Access Compliance Report Public Rights-of-Way (Curb Ramps)

Intersection ID: 15564 Main Street: CHEROKEE RD **Cross Street: COTTAGE PL** Location: NW ADA ID: 1BC2E7149F35 Ramp Type: PerpDiag Initial Pass/Fail: Fail **Overall Compliance: No Severity Score:** 25

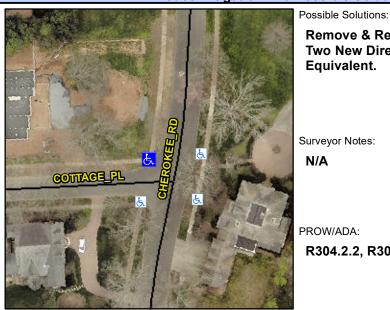
Equivalent. Surveyor Notes: N/A PROW/ADA: R304.2.2, R304.5.3

Comp	oliance Description	Data	Comp	liance	Description	Data
N/A	Ramp Length (in)	46.0	No	Ramp	Slope (%)	8.9
Yes	Ramp Width (in)	96.0	No	Ramp	XSlope (%)	6.8
N/A	Flare Type LT	N/A	N/A	Flare	Type RT	N/A
N/A	Flare Slope LT (%)	N/A	N/A	Flare	Slope RT (%)	N/A
N/A	Flare Traversable LT?	N/A	N/A	Flare	Traversable RT?	N/A
N/A	Landing Length (in)	N/A	N/A	DWS	Provided?	N/A
N/A	Landing Width (in)	N/A	N/A	DWS	Contrast?	N/A
N/A	Landing Slope (%)	N/A	N/A	DWS	Length (in)	N/A
N/A	Landing X Slope (%)	N/A	N/A	DWS	Full Width?	N/A
N/A	Landing Curb? (Y/N)	N/A	N/A	DWS	Offset (in)	N/A
N/A	Shared Landing?	N/A				
N/A	Gutter Ponding?	N/A	N/A	Gutte	r Slope (%)	N/A
N/A	Gutter Lip Ht (in)	N/A	N/A	Gutte	r X Slope (%)	N/A
N/A	Painted X Walk1?	No	N/A	Painte	ed X Walk2?	No
	X Walk 1 Direction	To SW		X Wal	k 2 Direction	To E
N/A	X Walk 1 Width (in)	N/A	N/A	X Wal	k 2 Width (in)	N/A
	X Walk 1 Slope (%)	8.2		X Wal	k 2 Slope (%)	1.6
	X Walk 1 X Slope (%)	0.2		X Wal	k 2 X Slope (%)	7.8

Remove & Replace Curb Ramp With **Two New Directional Ramps or**
